SAXON WEALD
DURRINGTON LANE
WORTHING
WEST ELEVATION

4242	LO	46	Revision: D

WEST FACING ELEVATION - BLOCK A

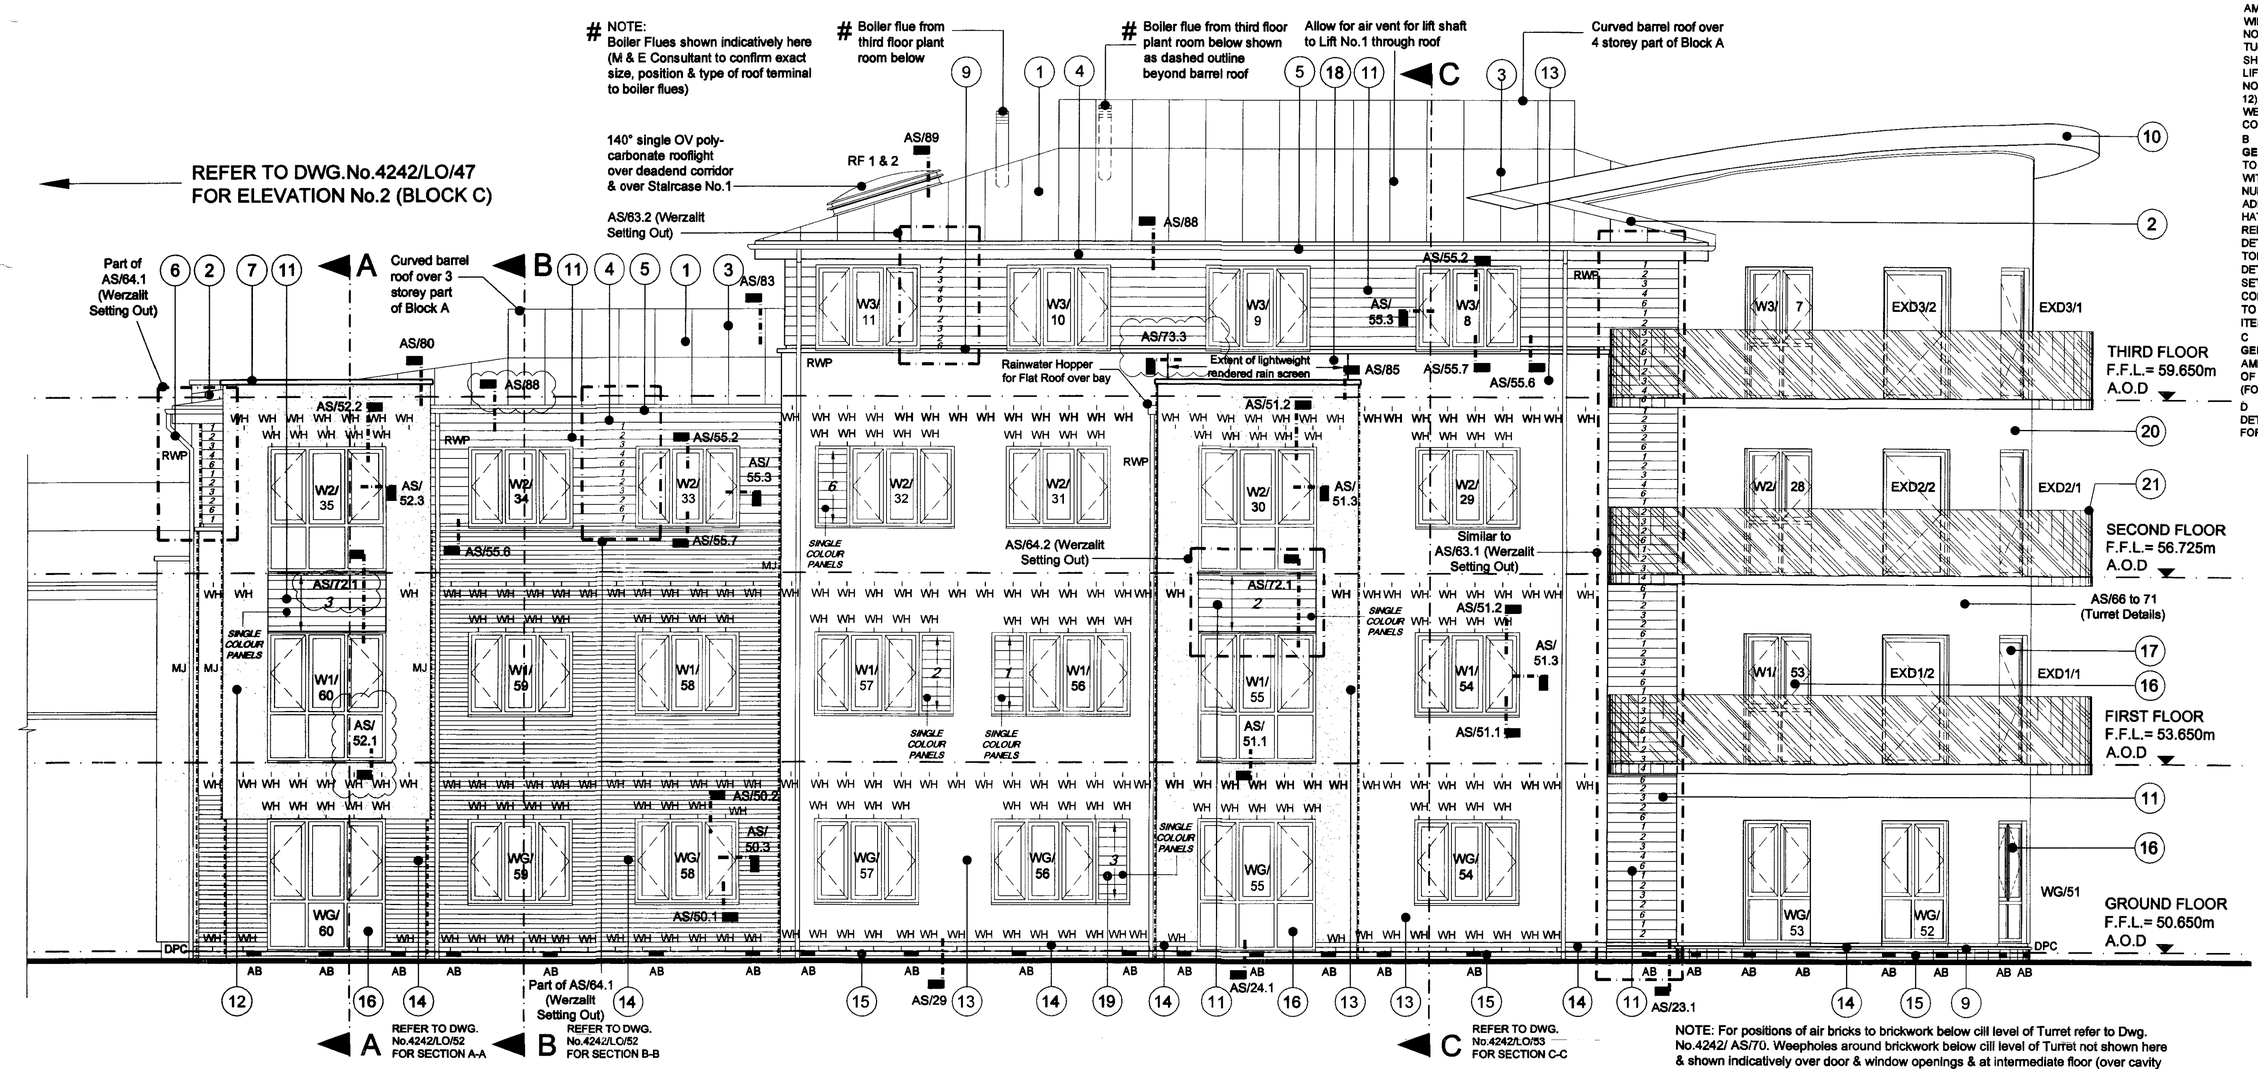
GENERALLY: ROOFS AMENDED IN ACCORDANCE WITH REVISED SECTION & TIMBER FRAME MANUFACTURERS DWG. PARAPETS AMENDED AS DETAILS. NOTES ADDED RE: AIR EXTRACTS TO END OF BARREL ROOFS. ADDED KEY NOTE REF. No.s, DETAIL REF.No.s & SECTION LINES. REFERENCE ADDED TO IN/07 (KEY PLAN OF ELEVATIONS). AMENDED REFERNCE TO WINDOW & DOOR DWG. NOW IN/09, 11 & 12. ADDED REFERNCE TO KEY TO NOTATION (LO/41). MOVEMENT JOINTS, RWPs, DPC, WEEPHOLES & AIR BRICKS SHOWN.
WEST FACING ELEVATION (3/4 STOREY - BLOCK A): AMENDED TURRET ROOF, WALLS BALCONY & WINDOWS/DOORS IN LINE WITH REVISED DRAWINGS. NOTE ADDED RE: WEEPHOLE AROUND BASE OF TURRET. LIGHTWEIGHT RENDERED RAIN SCREEN SHOWN OVER BAY TO 4 STOREY. FLUES ADDED. LIFT OVER RUN SHOWN TO 3 STOREY. WG/38 & 39 NOW SHOWN AS EXTERNAL DOOR TYPE T (EXDG/11 & 12). LARGE PROJECTING BAYS - AMENDED/SIMPLIFIED WERZALIT PANELS BETWEEN WINDOWS AND AROUND CORNERS - BMC

GENERALLY: WERZALIT CLADDING HATCHING ADJUSTED TO COURSE IN WITH ALL DETAILS (FOLLOWING MEETING WITH CLADDING PANEL MANUFACTURER). REFERENCE NUMBERS FOR WERZALIT CLADDING COLOURS & KEY ADDED ALONG WITH KEY TO RENDER COLOURS. HATCHING (DOTS) ADDED TO DENOTE RED COLOURED RENDERED BAYS. ROOFLIGHTS ADJUSTED AS REVISED DETAILS & ROOF PLAN. FURTHER WEEPHOLES ADDED T TOP OF RENDRED BAYS TO PARAPET WALL (AS REVISED DETAILS). ADDED DWG. REFERENCES TO WERZALIT SETTING OUT ELEVATIONS. NOTE ADDED RE: SINGLE COLOURED CLADDING PANELS. **WEST ELEVATION:-** NOT TO TURRET RENDERED CURVED WALLS CORRECTED TO ITEM No.20 (NOT 19).

GENERALLY: REFERENCES TO DETAILS ADDED OR AMENDED (AS CLOUDED) FOLLOWING COORDINATION OF / NEW DETAIL, FOR WERZALIT CLADDING PANELS (FOLLOWING MEETING MANUFACTURER). - BMC

DETAIL REFERENCES ADDED TO WEST ELEVATION FOR 4242/AS/73.03 - BMC
